Jet Needle Kit (Part No. 94114)

Figure 1. Install Silver "0603" Label on Carburetor (Optional)

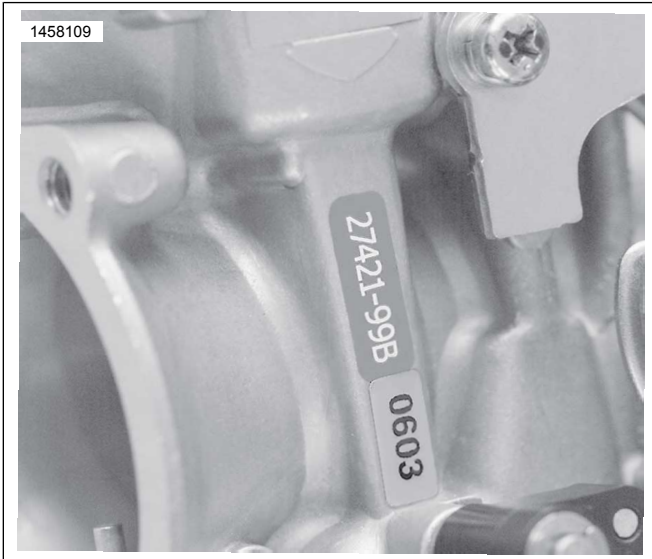
5. As proof of recall service, remove plastic backing to expose adhesive and firmly press silver "0603" label from kit onto rib of carburetor housing. Place label immediately above or below existing label bearing carburetor part number. While some overlapping of the labels may be unavoidable, please make an effort to keep overlap at a minimum. See Figure 1.
6. Install carburetor. See Section 4.4 CARBURETOR, INSTALLATION.
